Radio Frequency Analysis Report

Site MA-4388

196 West Street
Paxton, MA 01612

May 9, 2014

Exhibit 12: CW Drive Test Data @ 134 Ft. and Tuned 850 MHz Model

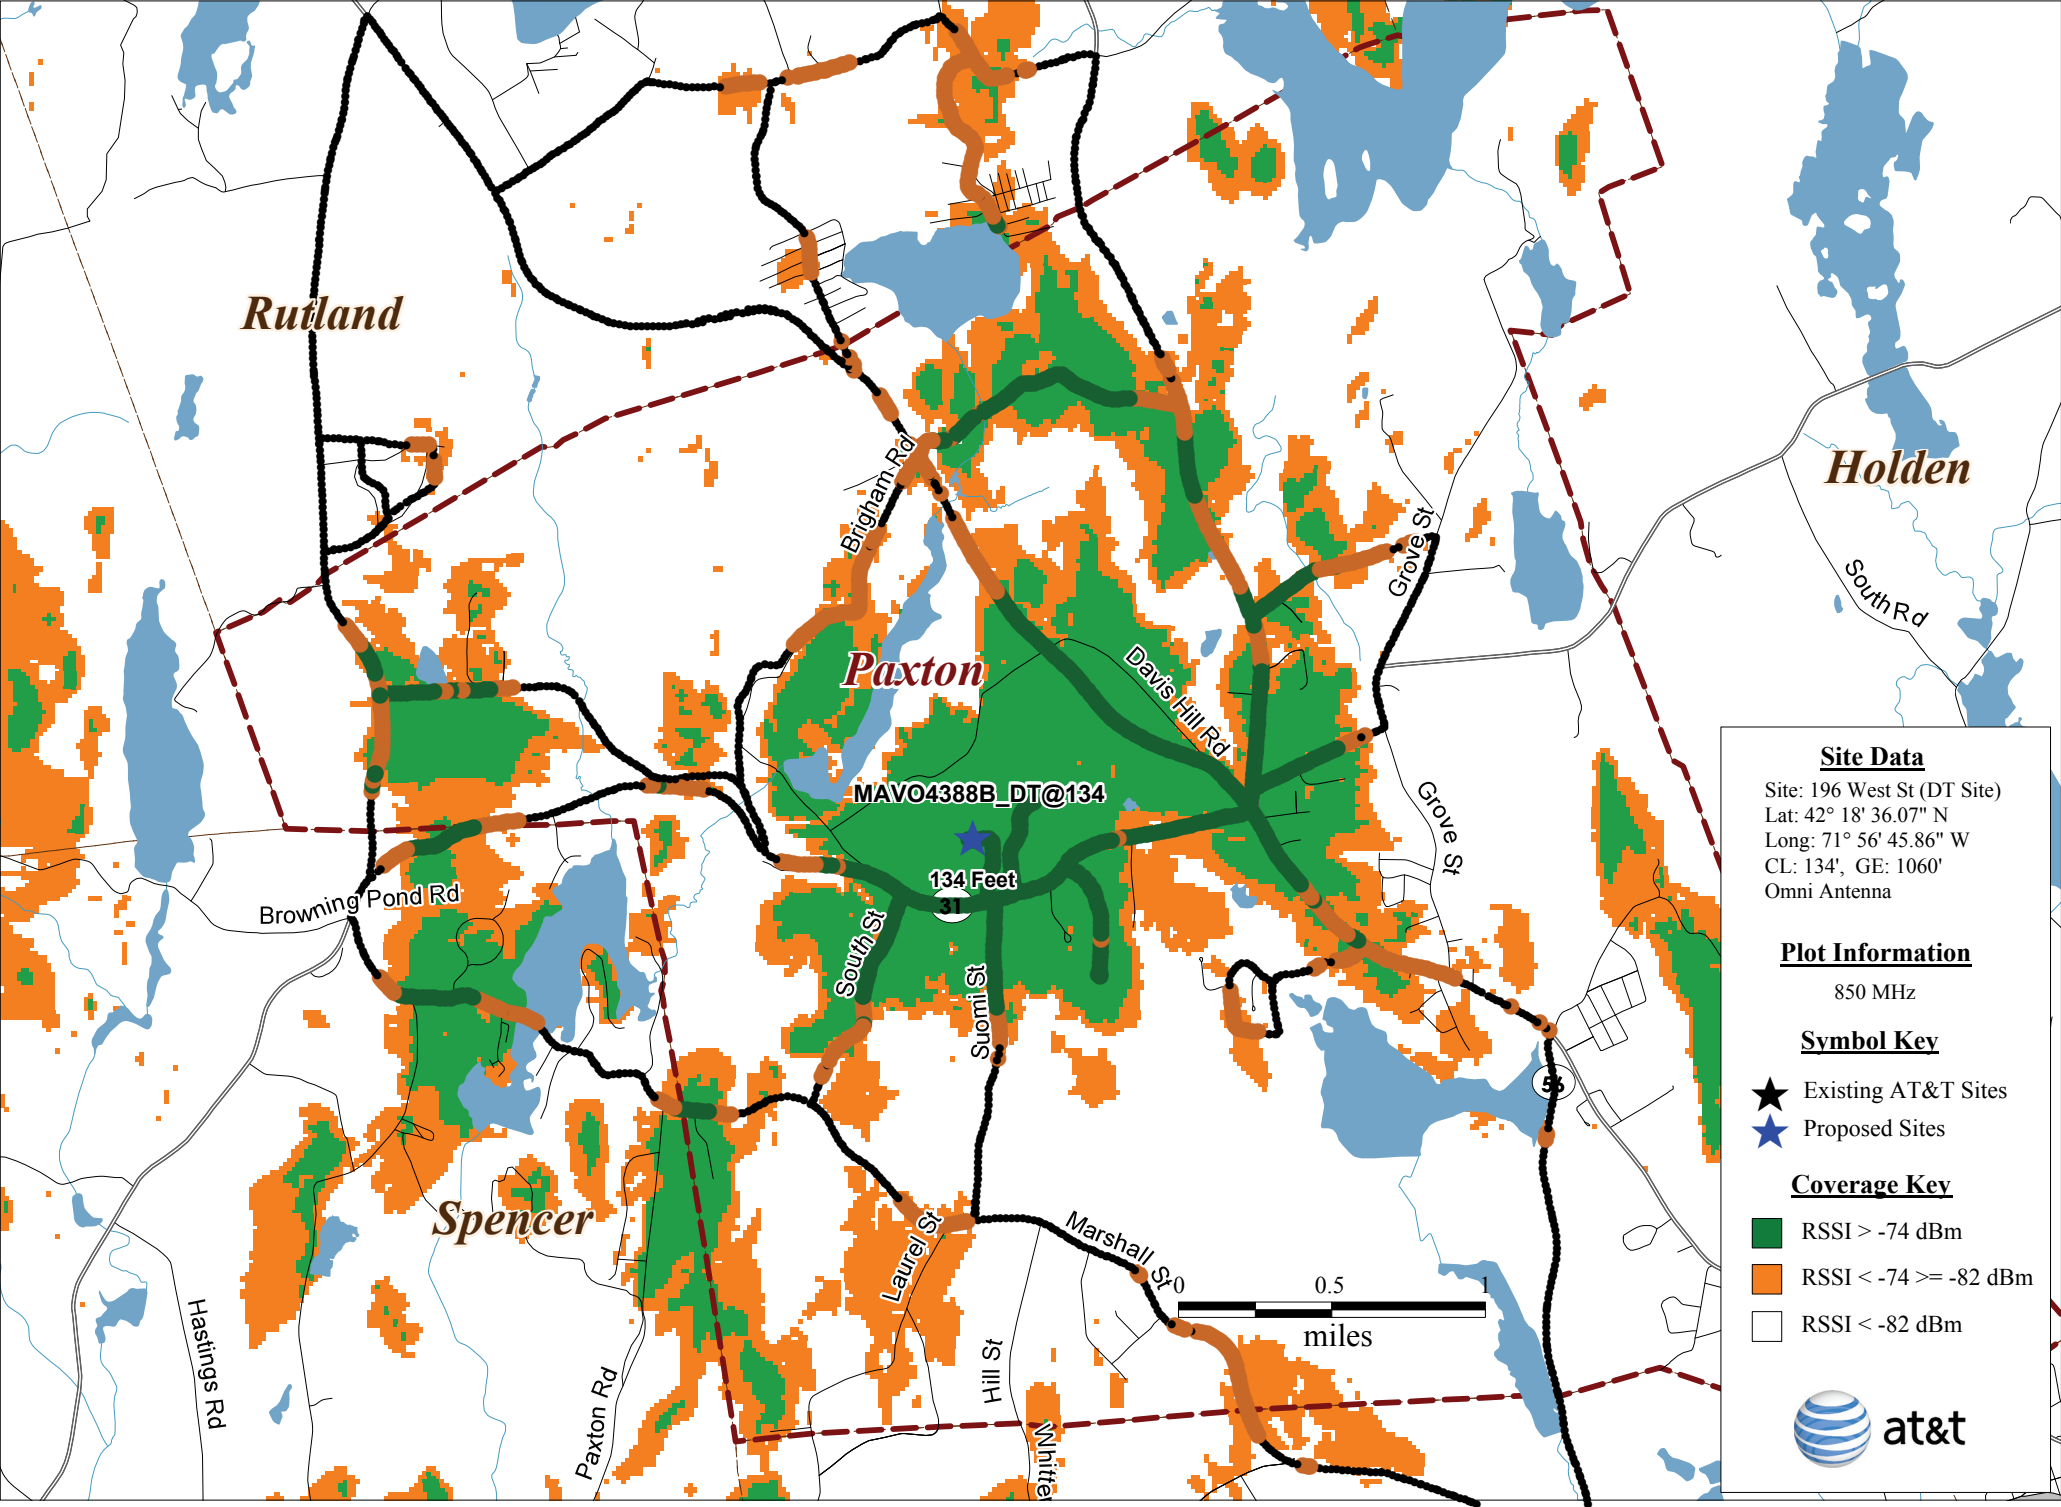
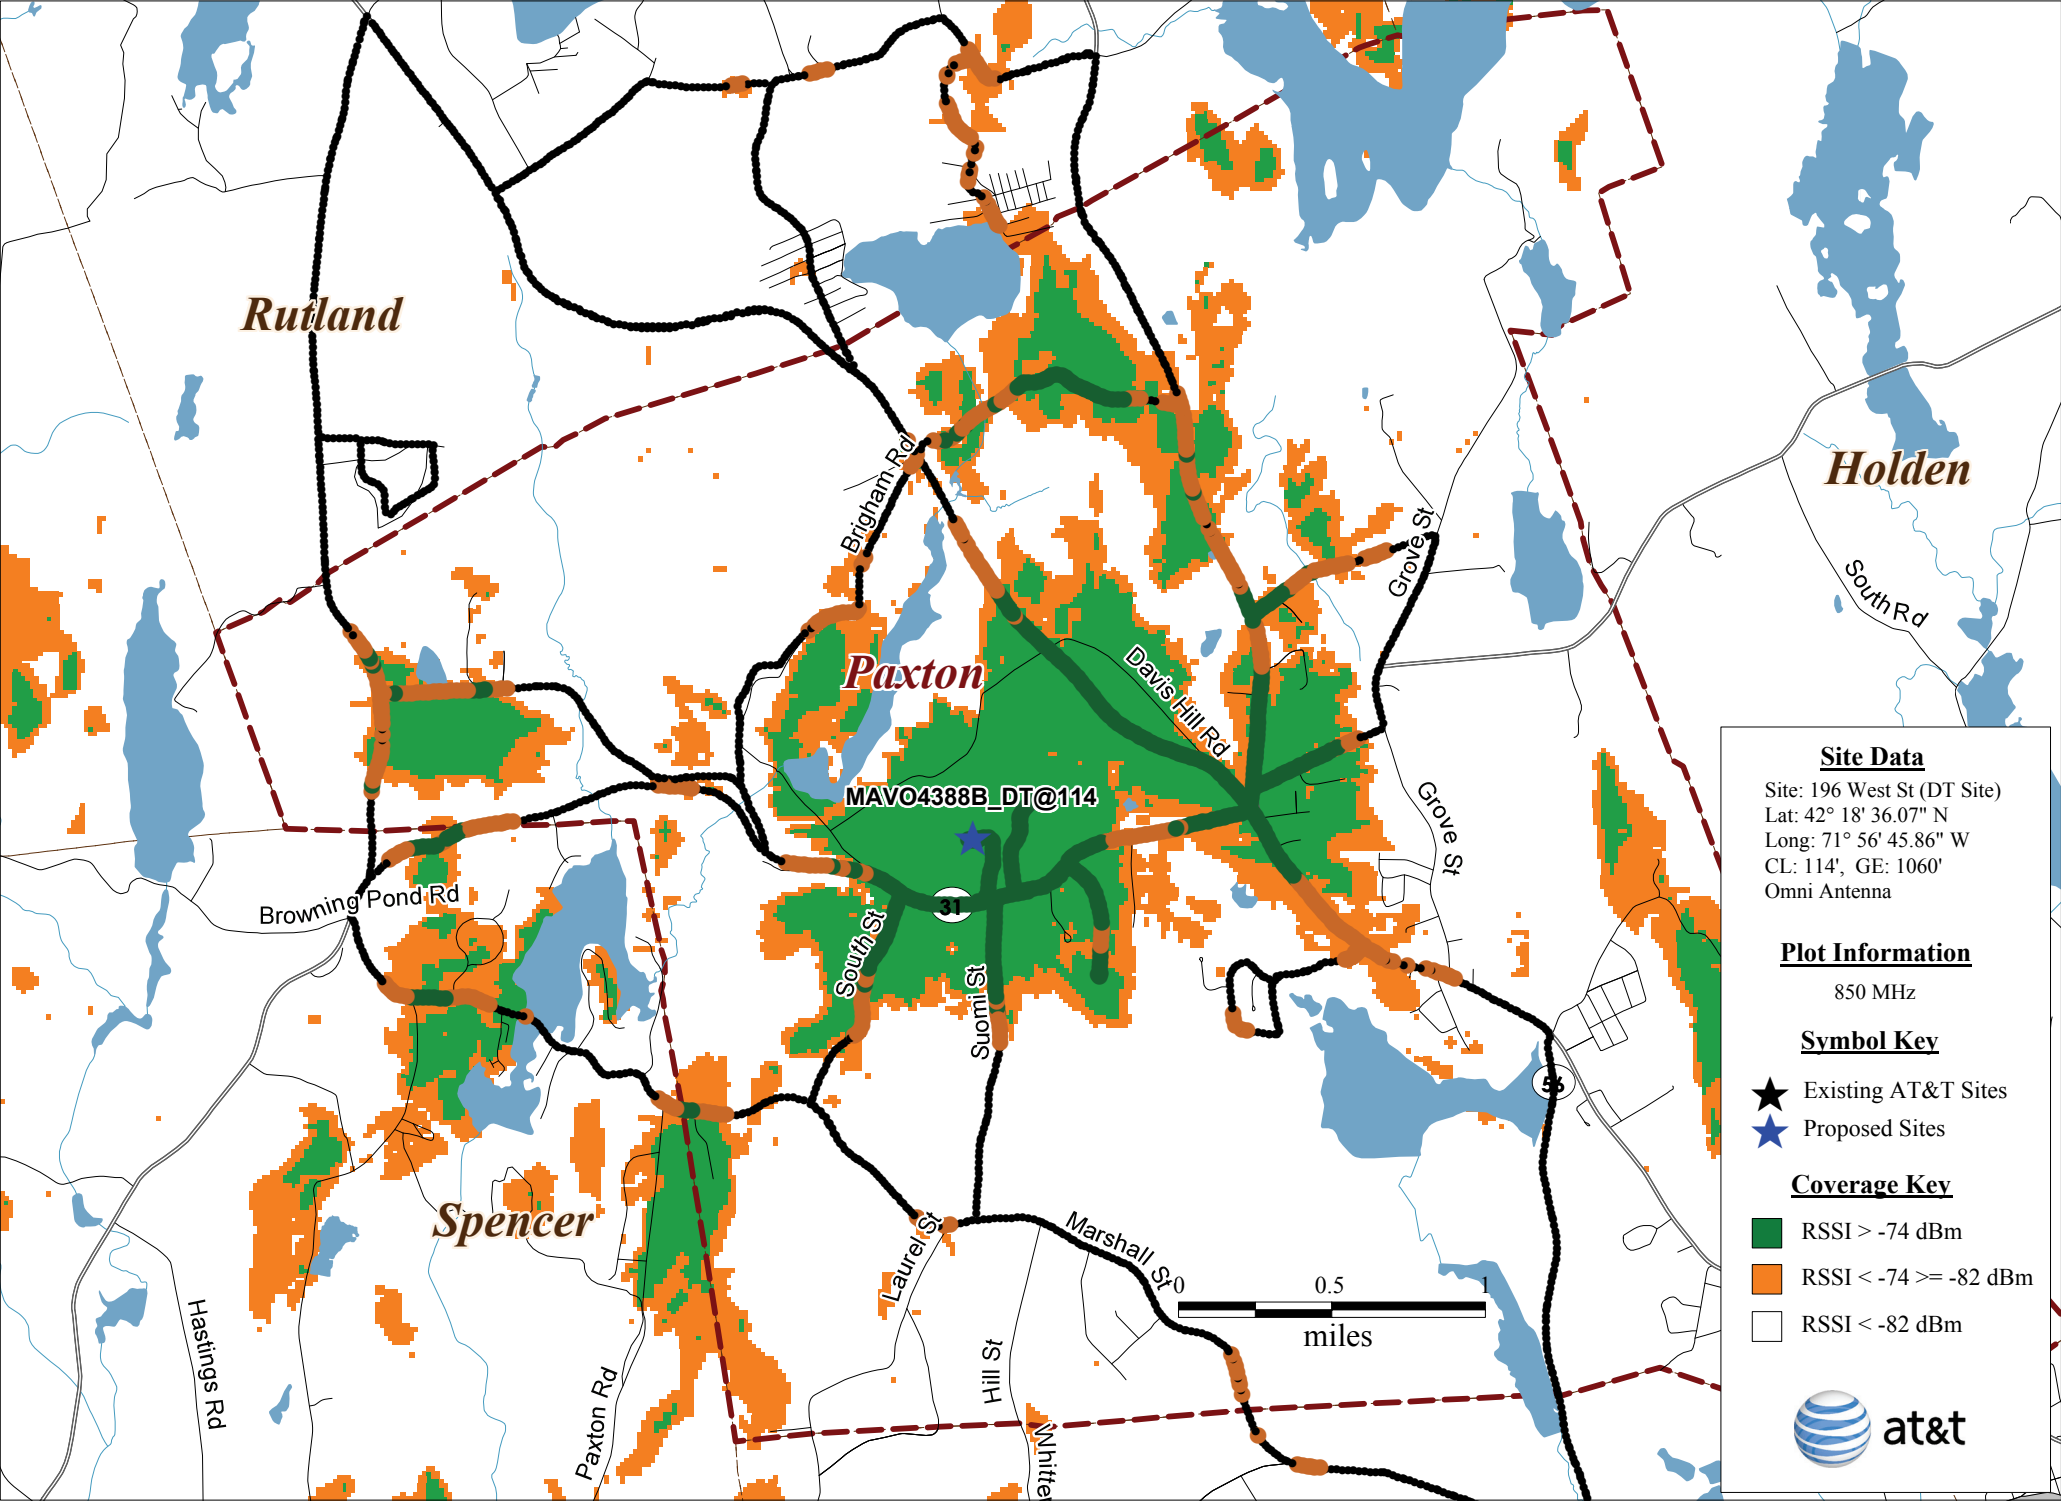
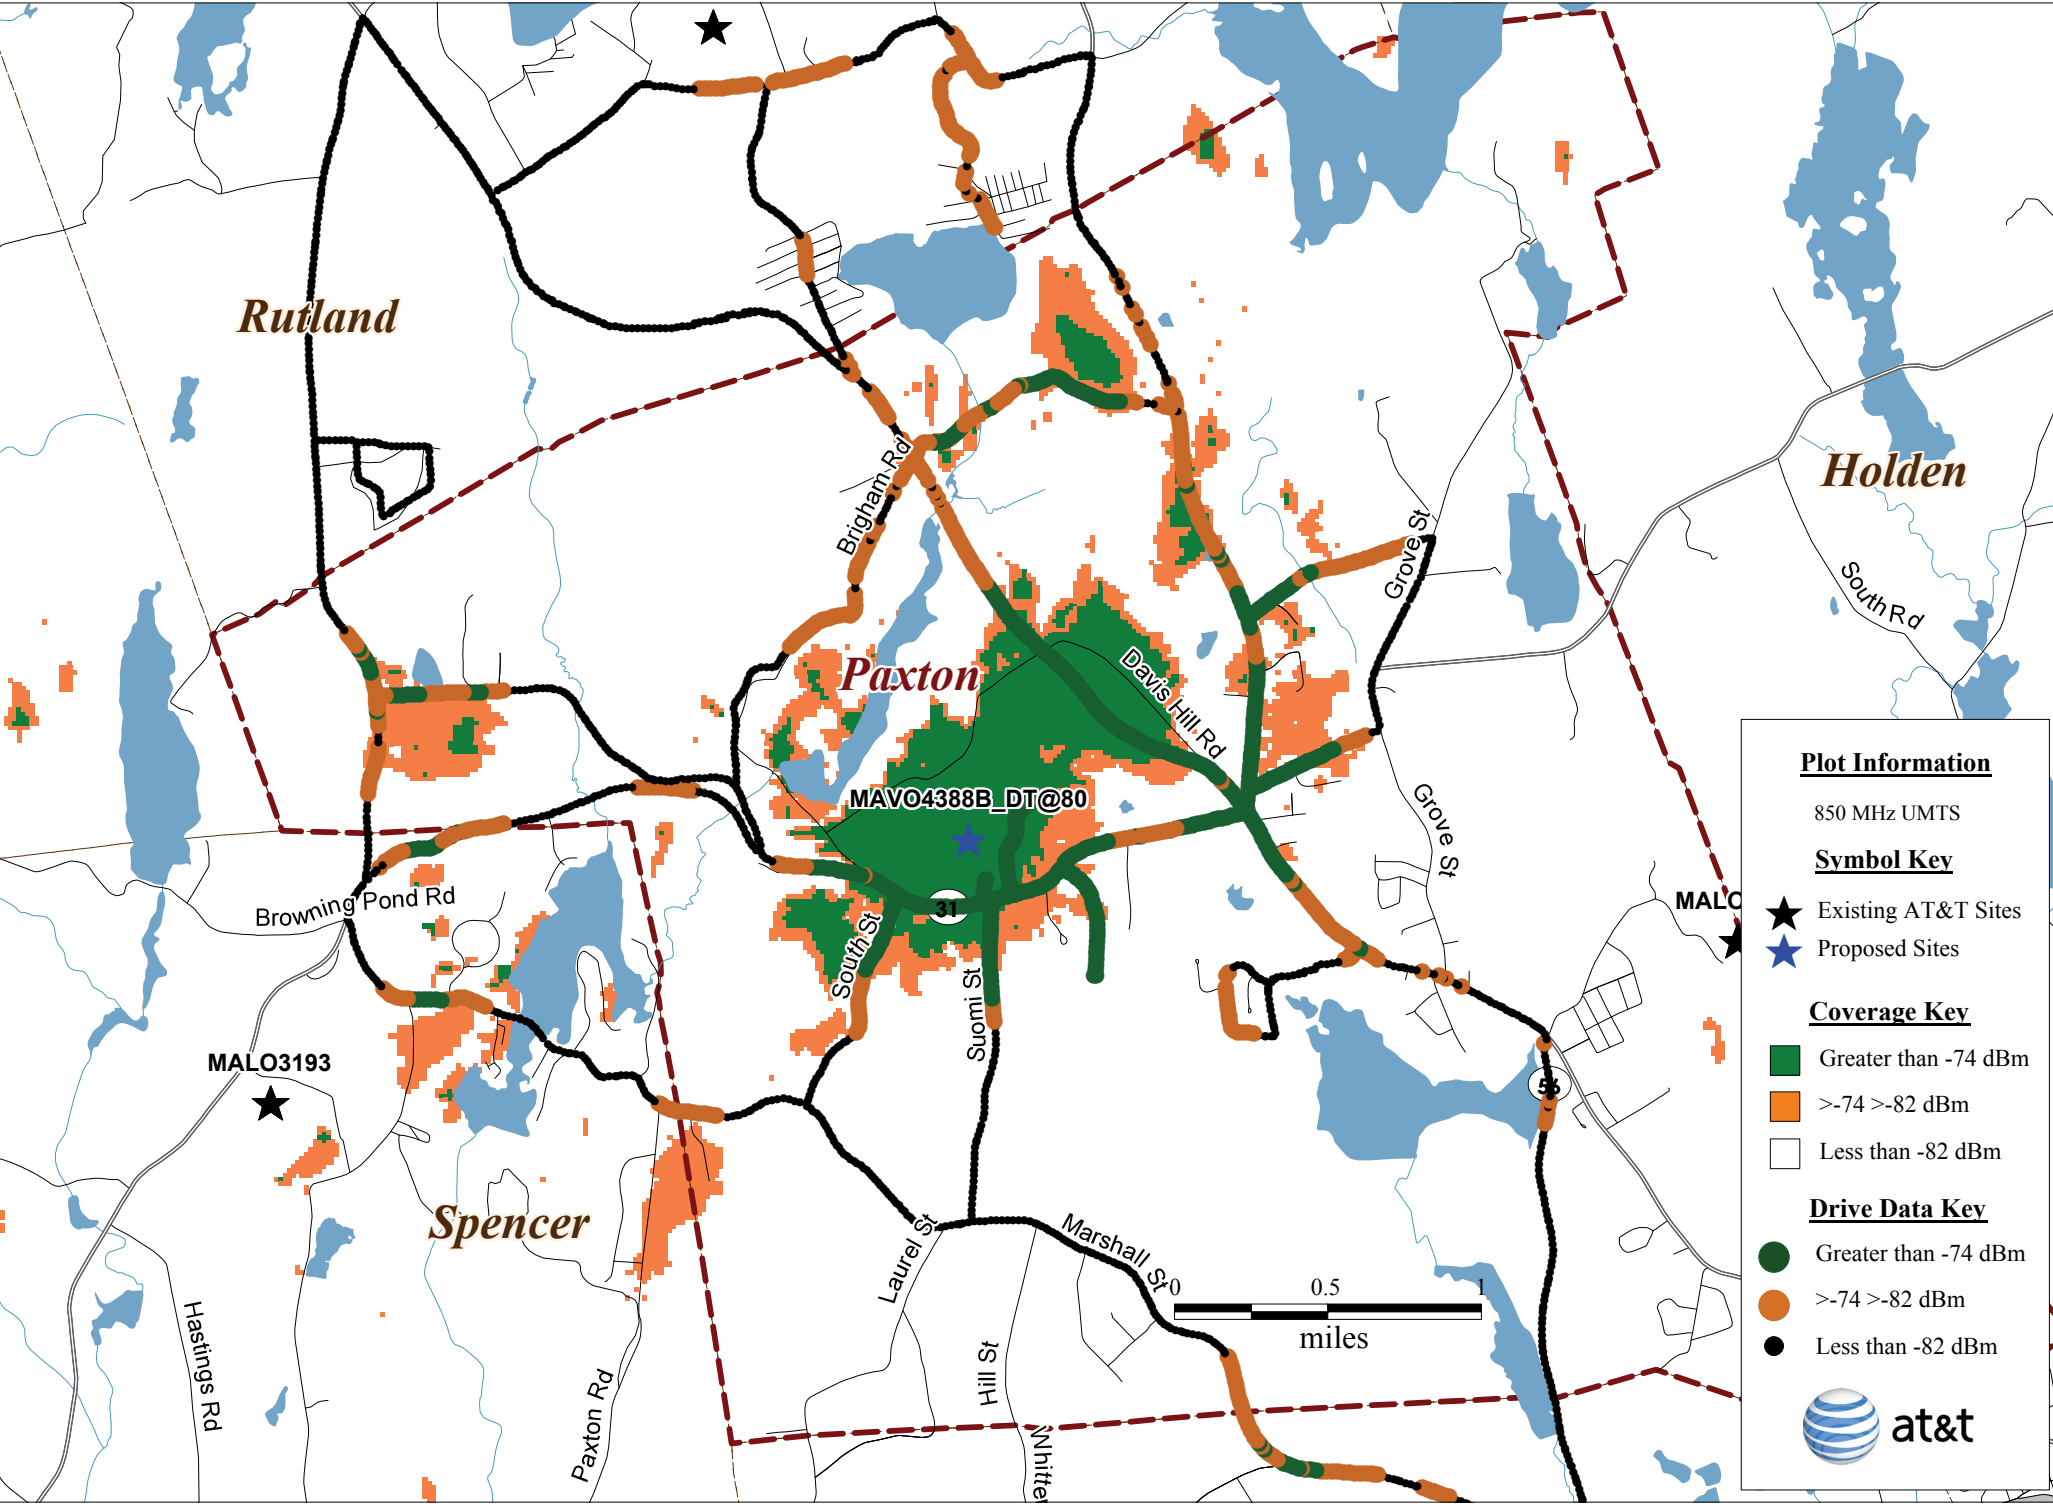
- Drive Test Maps – Mr. Graiff again questions the labels for the coverage maps provided at Exhibits 12, 13, and 14. The purpose of Exhibits 12 through 14 is to demonstrate (i) the results of the drive tests performed at the different heights, (ii) the accuracy of the underlying model, and (iii) the anticipated LTE coverage from the proposed Facility at the stated heights. Similar to the above explanation, the coverage depicted demonstrates the anticipated coverage from the Facility for LTE services. Therefore, in order to avoid any confusion, C Squared has revised the labels on these exhibits to correct them. As with the coverage plots mentioned above, it is important to note that it is only the label that was incorrect, and C Squared has verified that the proper inputs were used to generate the coverage depicted.
